RESPONSE TO AN BORD PLEANÁLA OPINION

**PROPOSED RESIDENTIAL DEVELOPMENT AT FRANKFORT CASTLE,
DUNDRUM, DUBLIN 14**

Pre-Application Reference No. - *ABP-306159-19*

Figure 1.0: Example of Measures Proposed to Reduce Potential Overlooking Along Site Boundaries (Source: Extract from Section 5.8 – OMP Architectural Design Statement).

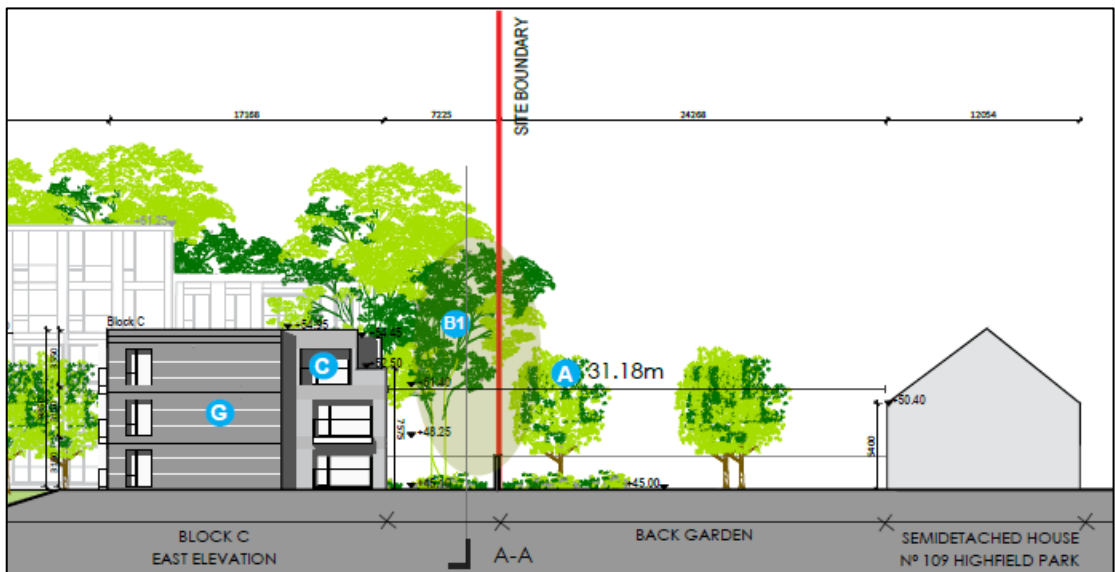
A report (or reports) that addresses issues of residential amenity (both existing residents of nearby development and future occupants), specifically with regards to daylight/sunlight analysis, overshadowing and potential overlooking. The report shall include full and complete drawings including levels and cross-sections showing the relationship between the proposed development and nearby residential development.

With regard to overlooking, Section 5.0 of the enclosed 'Architectural Design Statement', prepared by OMP, addresses this topic comprehensively. OMP note that a number of design measures have been incorporated into the scheme to remove the potential for overlooking. These measures include building setbacks on upper levels, directional windows, blank facades, and inset balconies. In addition, generous separation distances are achieved and

trees are either proposed or retained along boundaries to further reduce potential overlooking concerns.
